# **Atascadero – San Luis Obispo 70 kV Power Line Reconductoring Project Initial Study/Mitigated Negative Declaration Final**

**February 2011**

5.3 Responses to Letter B: Robyn Salvadori, Senior Land Planner,  
Pacific Gas and Electric Company ..... 5-14

Figure 2.4-14: Power Line Segment (14 of 35)

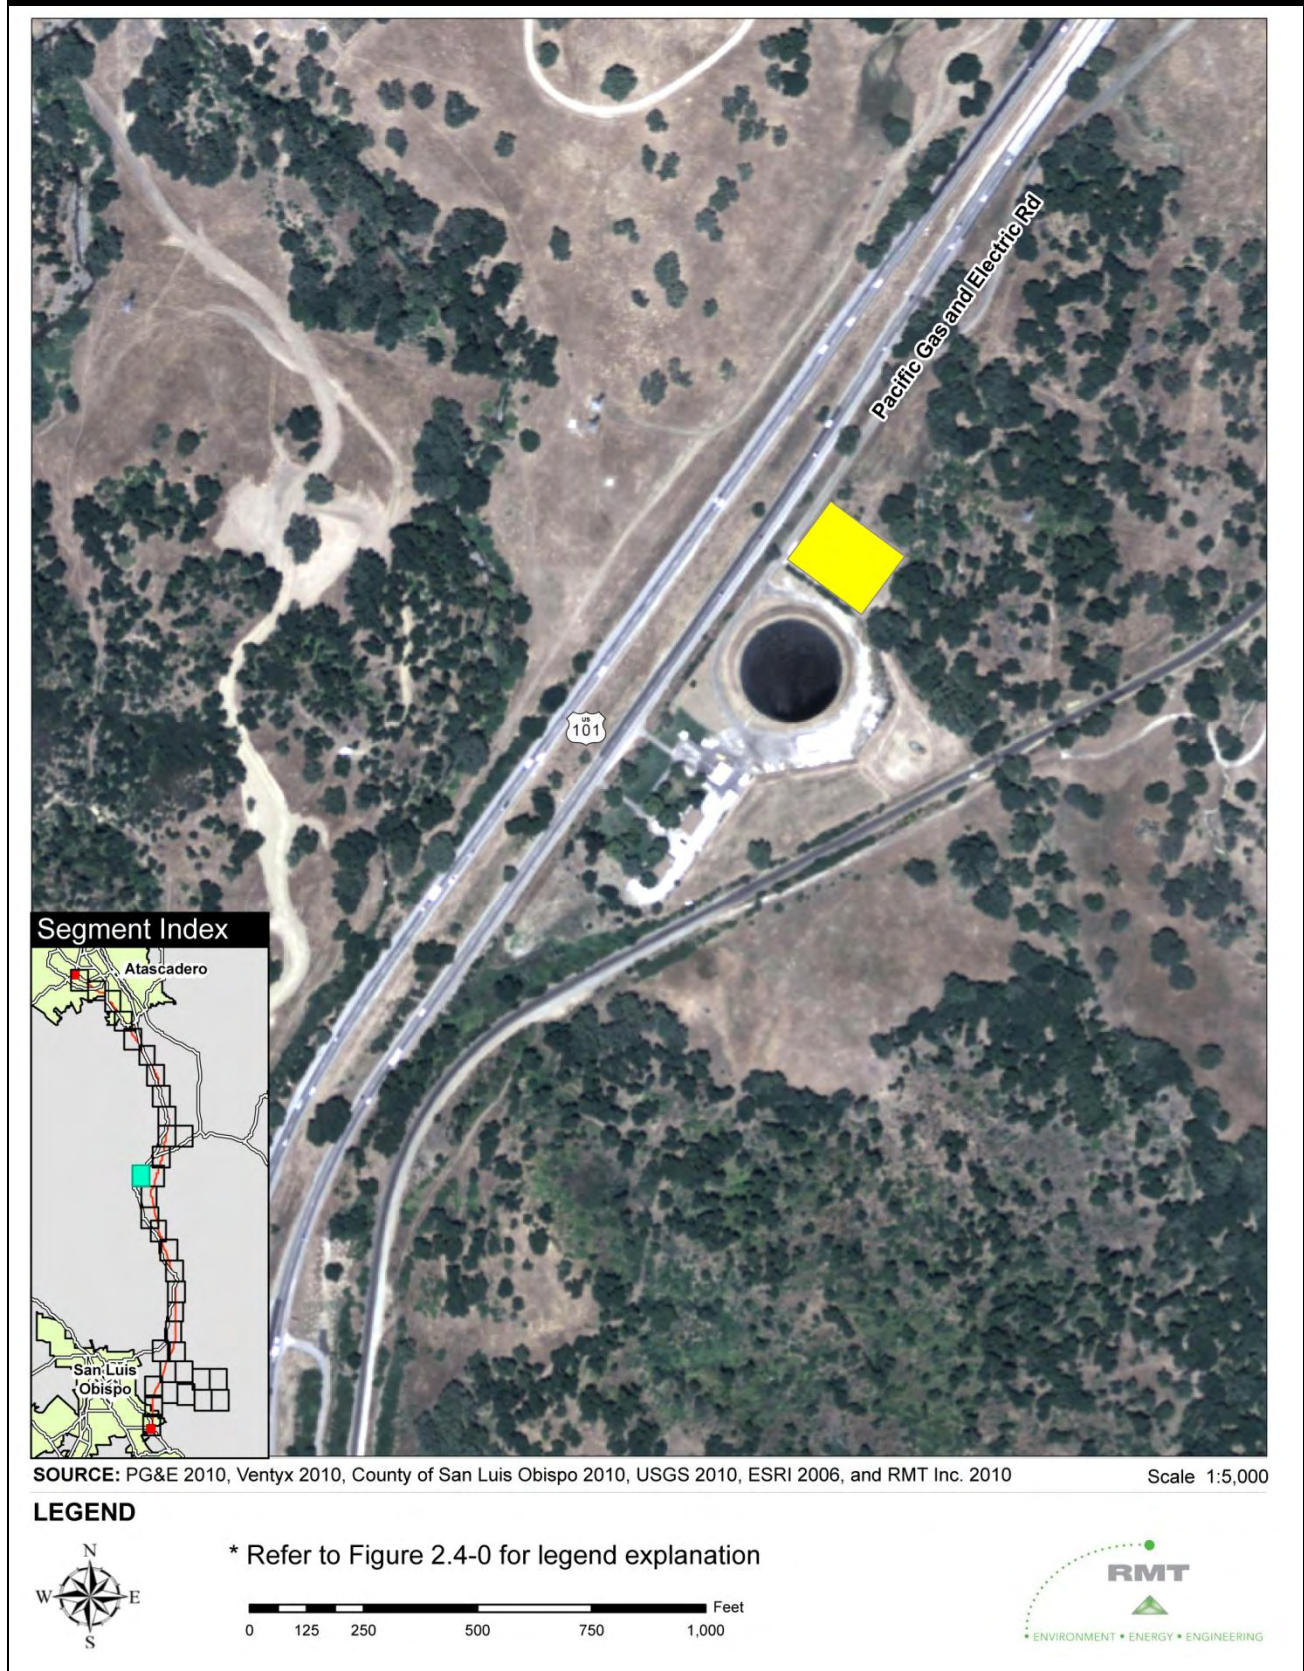
E-7 Sensitive Receptors  
The Temporary Work Area on Wilhemina Avenue in the community of Santa Margarita that is identified in Figure 2.4-13 on page 2-19 of the IS/MND looks to be in violation of air quality mitigation AQ-3, sub-measure 1a. This measure states that construction staging areas shall not be located within 1,000 feet of sensitive receptors. Residential dwellings are within 1,000 feet of the proposed area. **Please define a replacement area that is removed from residential areas and that limits sensitive receptor impacts from diesel traffic. Prior to starting the project, submit this new selected area to the APCD Planning Division for review and approval.**

Memorandum  
Page 2 of 2

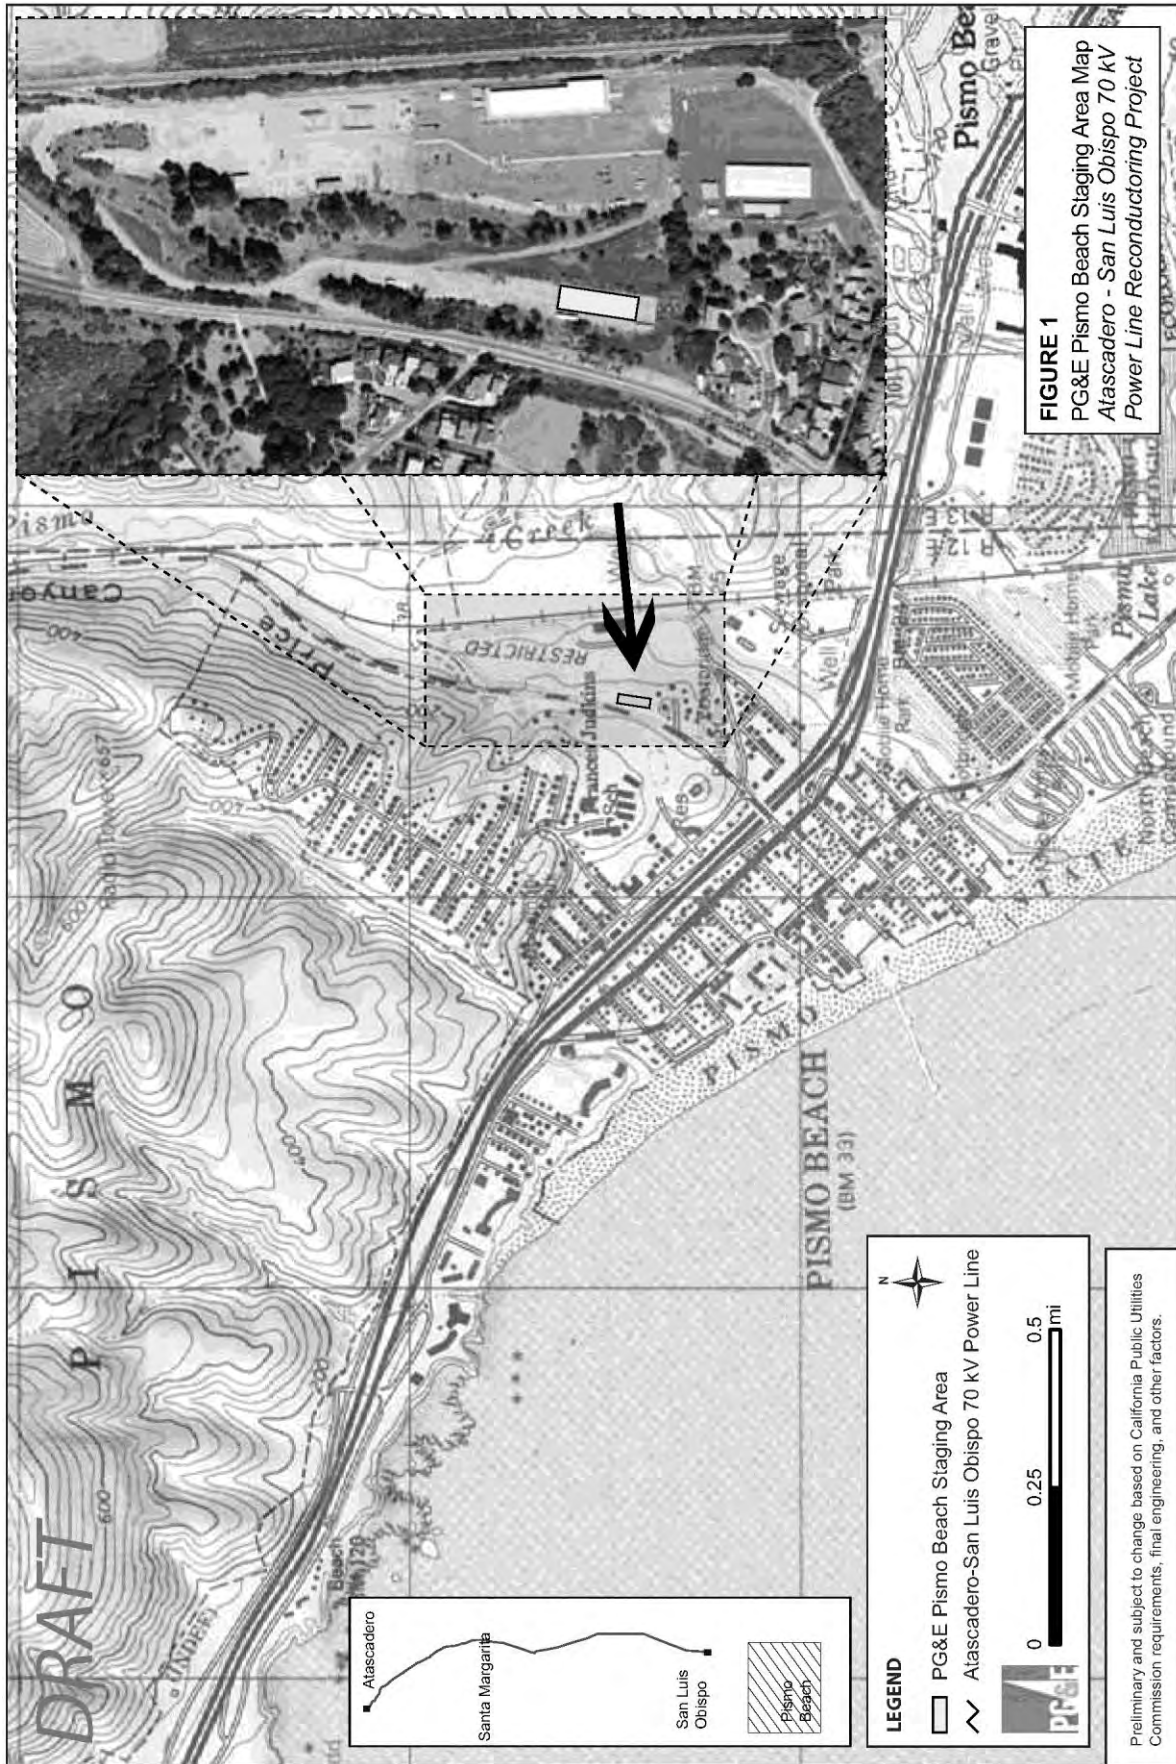
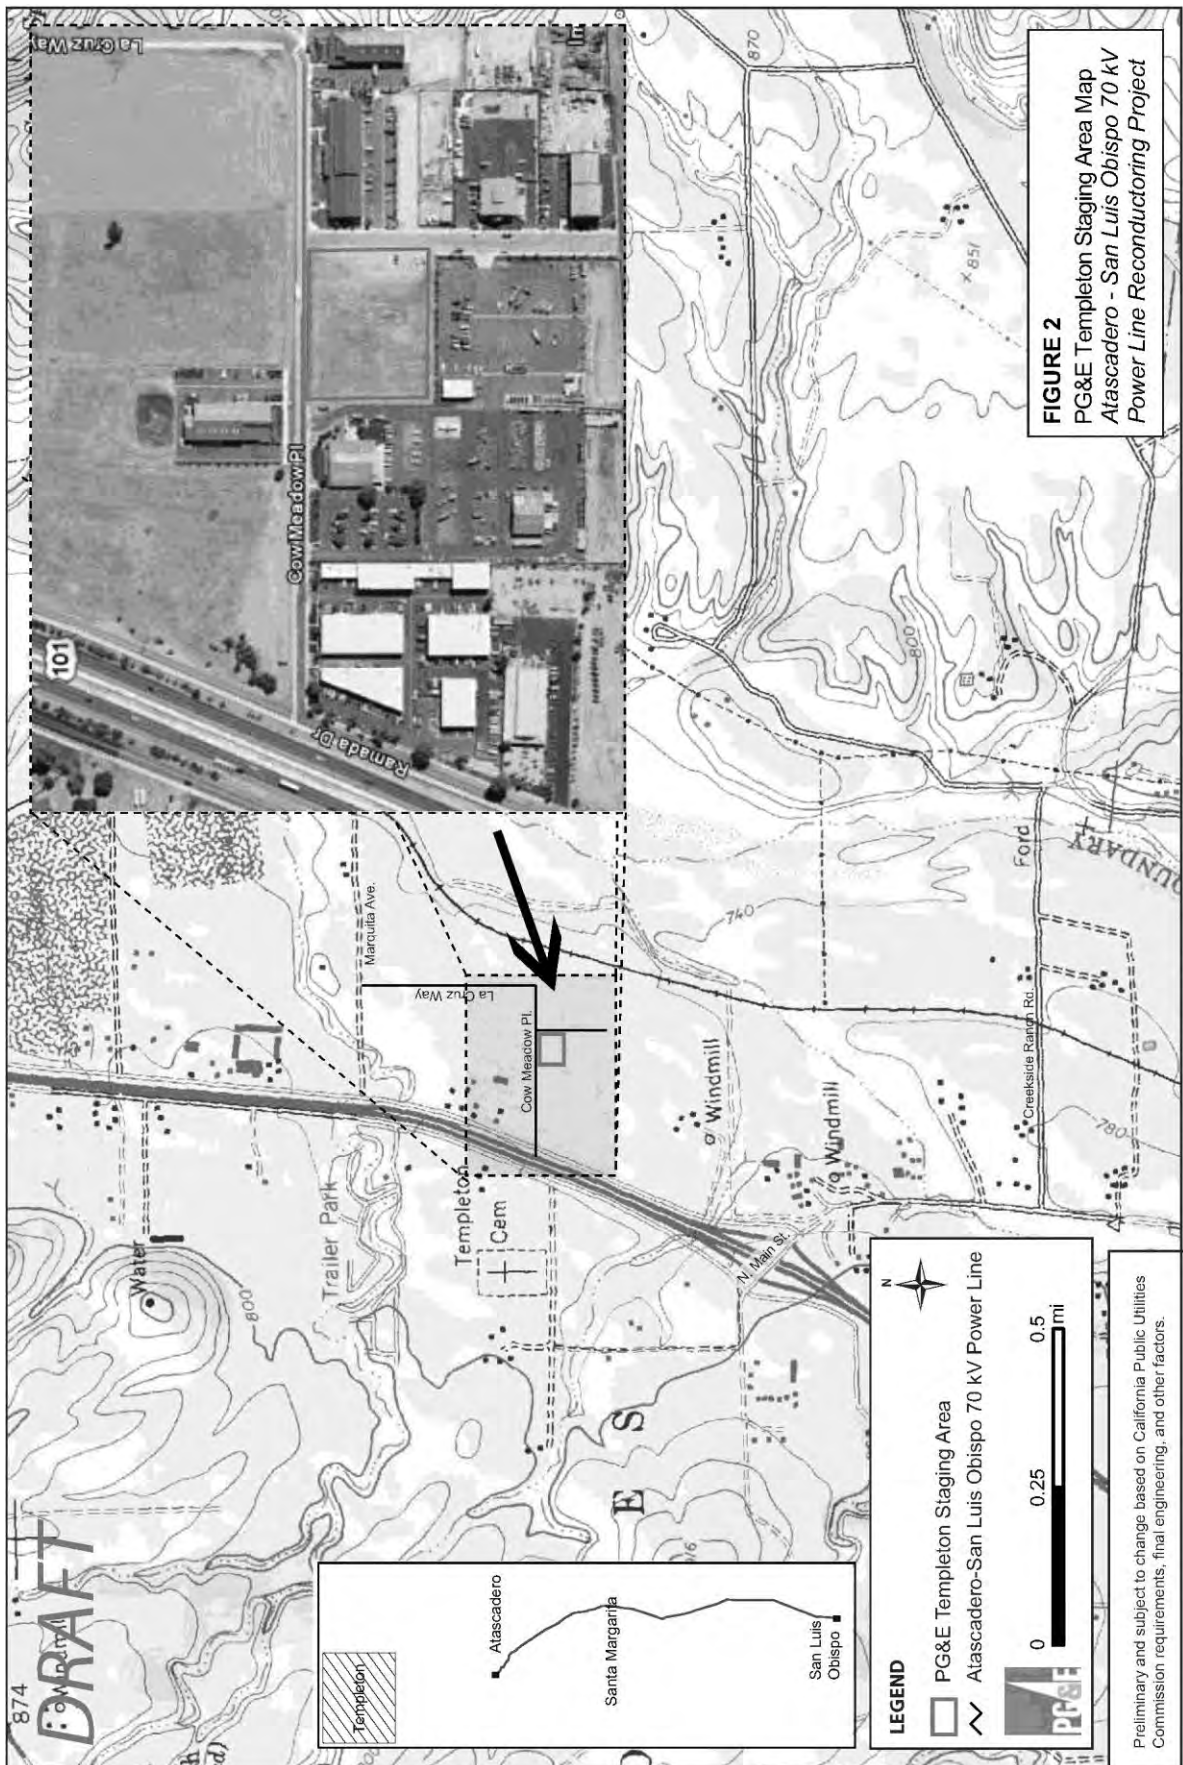
B-12 The information regarding the 5-acre previously disturbed lot located east of the PG&E Templeton Service Center and the PG&E Pismo Beach yard, as discussed in the attached memorandum from Mark Cassady, TRC, for the use as temporary work areas was added to the Project Description in section 2.5.2. Figure 2.5-2 was added to the Project Description to show the temporary work areas in the PG&E Templeton Service and Pismo Beach areas.
